Car Stereo Service Bulletin

Model: XES-C1 No. 374

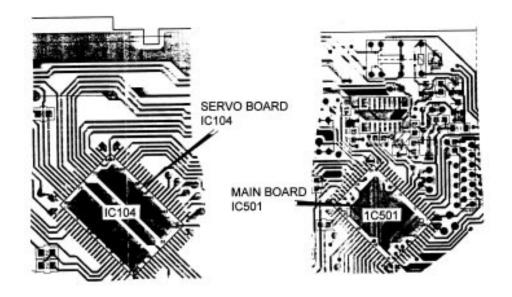
(**) The original signal processor IC104 (CXD2500Q) is no longer available, and is

being replaced by type CXD2500**B**Q. This new type signal processor IC is not compatible with the original system control IC501 (uPD75116GF-E25-3BE).

Solution: When replacing the original signal processor IC104 with the new type

(CXD2500BQ) you must also replace the system control IC501 with type

uPD75P116GF-3B3.
